P5025A-03A-S

Safety Service Note

P5025A Keysight Streamline USB Vector Network Analyzer

“POTENTIAL BURN INJURY (HIGH TEMPERATURE) HAZARD”

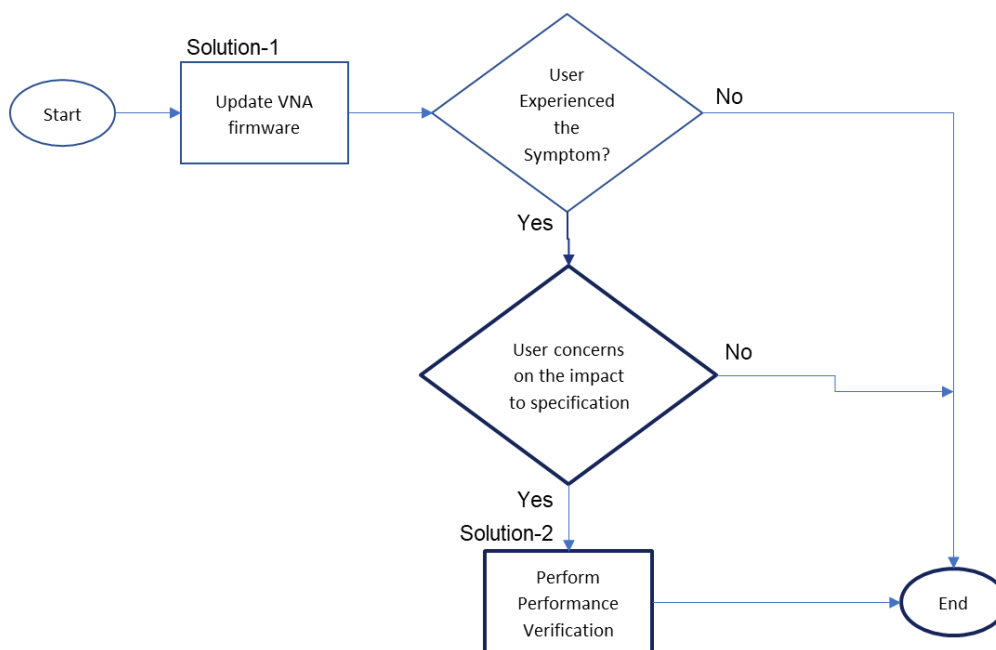
VNA fails to start with the following symptoms.

1. LED indicator (below circle) turns red.
2. cooling fan does not work
3. If user leaves the VNA with this LED indicator red without turning off power switch, it continues to overheat and becomes too hot.

Solution-1: Update VNA firmware by user

Action-1: Updating the firmware eliminates this potential risk of overheating.

1. **Install the latest VNA firmware Rev. A.15.55.14 or newer** on users' controller PC(s).
The latest firmware enhanced the thermal fan control mechanism.
2. Once the latest firmware is installed, proceed with the restart of both **controller PC** and **VNA**.
3. Launch the VNA firmware. Ensure VNA powers up and launches into firmware correctly after firmware update is done.
